Subject: Effects of the proposed East Cat Canyon Oil Field Redevelopment Project equipment layout change on the reported noise impact

Per your request, we have reviewed the documents provided by Padre Associates, Inc. regarding the proposed equipment layout changes for the Aera Energy (LLC) East Cat Canyon Oil Field Redevelopment Project (Project). The following analysis reviews the proposed changes in an effort to determine if the proposed changes in the equipment layout are significant enough to necessitate a revision of the noise impact analysis reported in the *East Cat Canyon Oil Field Redevelopment Project Noise and Vibration Impact Analysis Report* (Behrens and Associates, Inc., February 5, 2015).

Figure 1 Project CPF and GS/SGS Areas

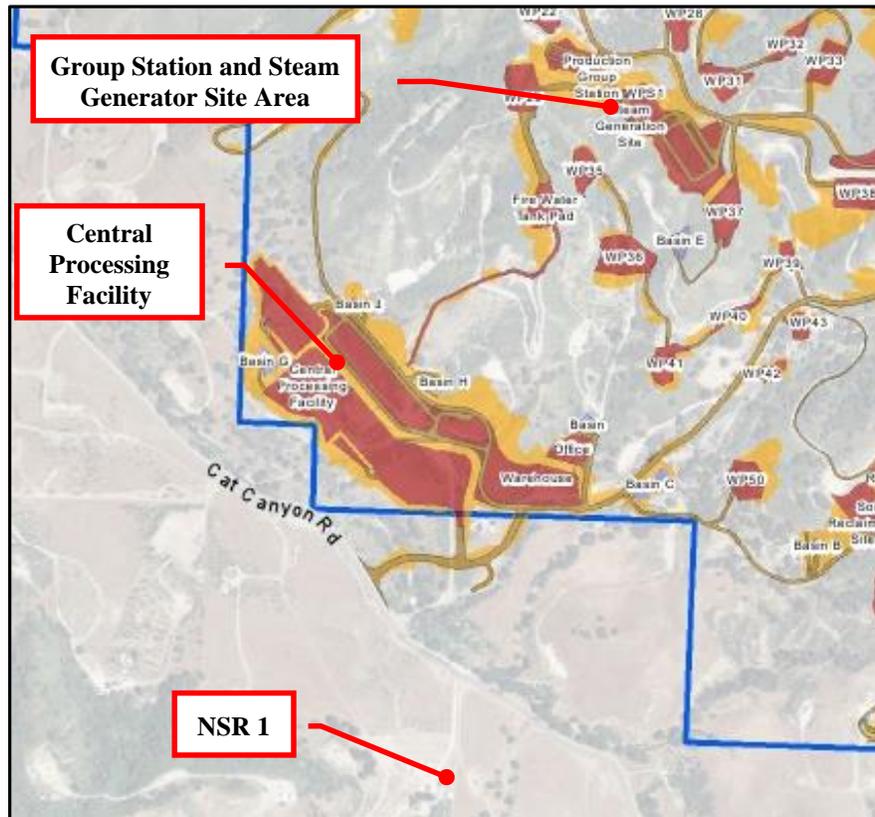
For convenience, Figure 1 below shows a section of the Project area that is relevant to the proposed changes. The CPF and GS/SGS areas are marked on the map. Also, the nearest noise sensitive receiver (NSR 1) utilized in the noise impact report is marked on the map. The Project property line is shown in blue.

As can be seen in Figure 1, relocating the equipment from the CPF to the GS/SGS area will increase the distance between the equipment in question and both the Project property line and NSR 1. Additionally, shifting the truck rack configurations to the north end of the truck loading area at the CPF will increase the distance between idling trucks and both the Project property line and NSR 1. As noise attenuation increases with distance, it follows that the noise impact of the equipment in question would decrease at the Project property line and at NSR 1.

The proposed equipment layout changes were reviewed and it was determined that the distance between the relocated equipment in question would increase in relation to both the Project property line and noise sensitive receivers resulting in a decrease in noise impact from the equipment. As a result, the conclusion reported in the *East Cat Canyon Oil Field Redevelopment Project Noise and Vibration Impact Analysis Report* of a less than significant production noise impact at the property line and noise sensitive receivers will not be affected by the proposed equipment layout change and further noise modeling and analysis of the Project production operations is not recommended.
